SUBJECT: ISSUANCE OF AMENDMENT NO. 62 TO FACILITY OPERATING LICENSE
NO. NPF-29 - GRAND GULF NUCLEAR STATION, UNIT 1, REGARDING
TECHNICAL SPECIFICATIONS REVISIONS - THERMAL HYDRAULIC STABILITY
(TAC NO. 71808)

Amendment No. 62
License No. NPF-29

ATTACHMENT TO LICENSE AMENDMENT NO. 62

SAFETY EVALUATION BY THE OFFICE OF NUCLEAR REACTOR REGULATION

FIGURE 3.4.1.1-1 POWER-FLOW STABILITY REGIONS

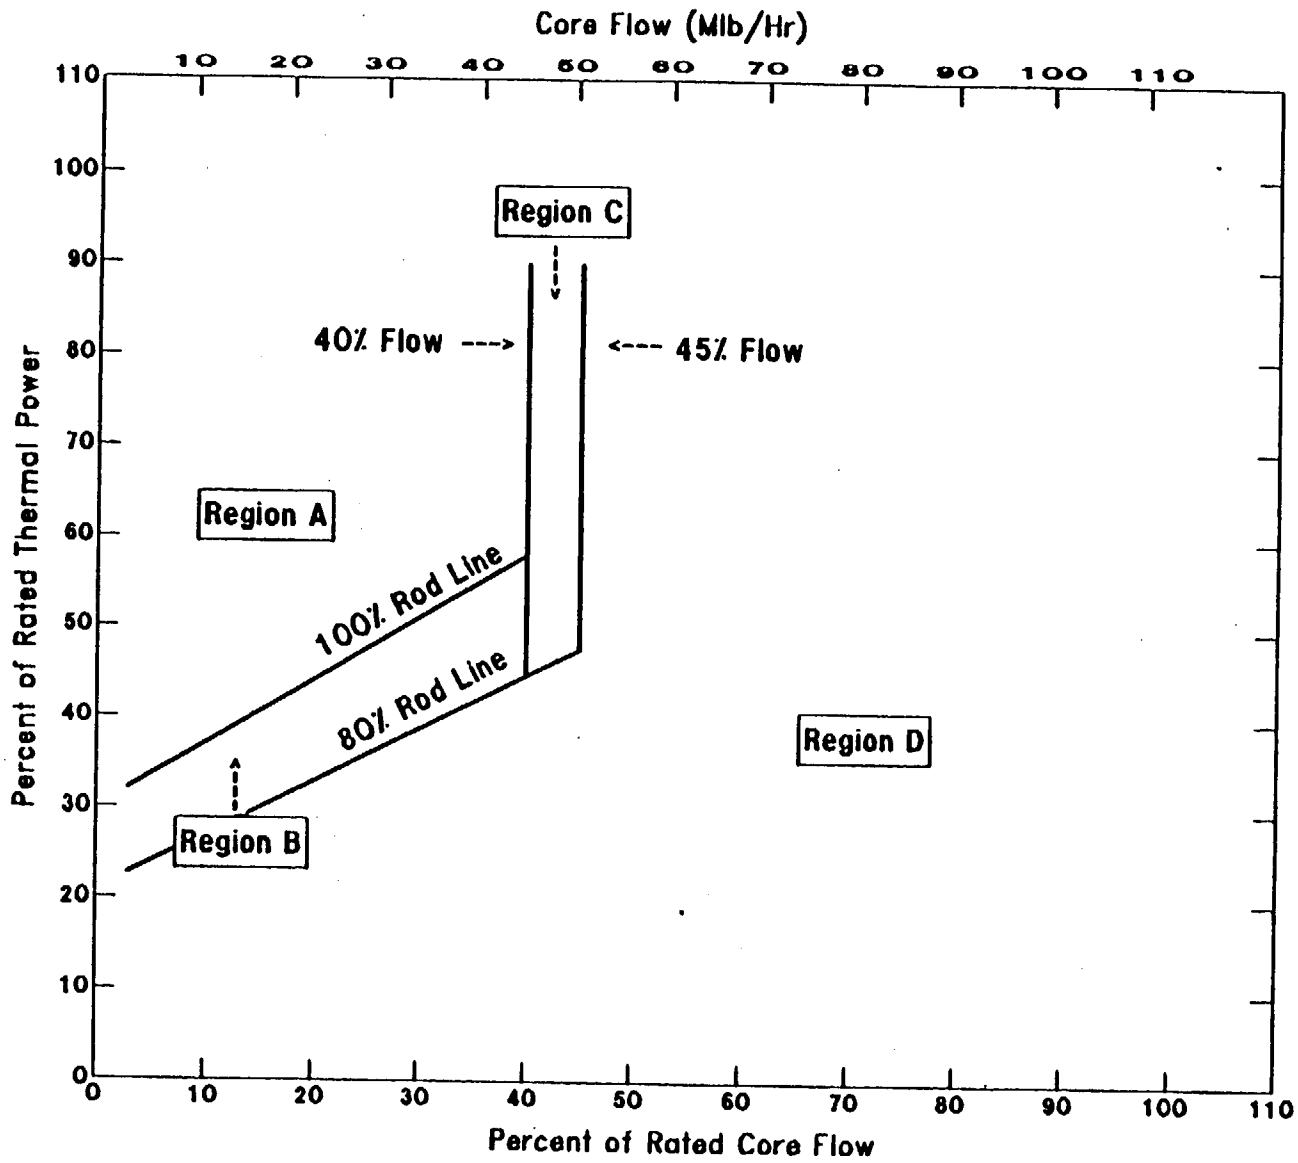
The amendment changes the TS by deleting TS 3/4.3.10, Neutron Flux Monitoring Instrumentation, and modifying TS 3/4.4.1, Recirculation System. Figure 3.4.1.1-1, Power Flow Operating Map, is changed to redefine flow stability regions. TS 3/4.4.1 is changed to reflect the redefined regions of Figure 3.4.1.1-1. The Bases for TS 3/4.3.10 and TS 3/4.4.1 are changed to reflect the changes in these TS.

Proposed changes to TS 3/4.4.1 affect only the sections relevant to THS (although the order of some other sections is changed). The primary changes are to Figure 3.4.1.1-1 altering the current region boundaries and designations so that they correspond to the IRSA regions. This changes the boundaries of current region I somewhat (and changes the designation to region C) and separates current region IV into IRSA regions A and B. The Specification prohibits operation in region A and B, and to some extent in region C. It requires, if the regions are entered, departure by scram in region A and by control rod insertion or flow increase (if a recirculation pump is operating at fast speed) in region B and C. (Bulletin, Supplement 1, allows entry into, and through, region C for flow increase departure from B.) Operation in region C is permitted for control rod withdrawals during startup for required fuel conditioning. (This would include restart or power increase from zero or low power conditions, but not other types of operations in region C, e.g., rod pattern exchange.) The TS also requires immediate scram, when the reactor mode switch is in the RUN position, when both recirculation pumps are not operating. (This does not include deenergizing during pump speed transfers.) This is in compliance with the staff request in the Bulletin Supplement.

Operation is not permissible in Regions A, B or C as specified in Figure 3.4.1.1-1 except that operation in Region C is permissible during control rod withdrawals for startup.

The power/flow operating map is divided into four (4) regions. Regions A and B are restricted from operations. They include the operating area above the 80% rod-line and below 40% core flow. Region C includes the operating area above the 80% rod-line and between 40% and 45% core flow. Operation in Region C is allowed only for control rod withdrawals during startup for required fuel preconditioning. Region D consists of the rest of the operating map. No core thermal-hydraulic stability related restrictions are applied to Region D since the potential onset of core thermal-hydraulic instabilities is not predicted within Region D.
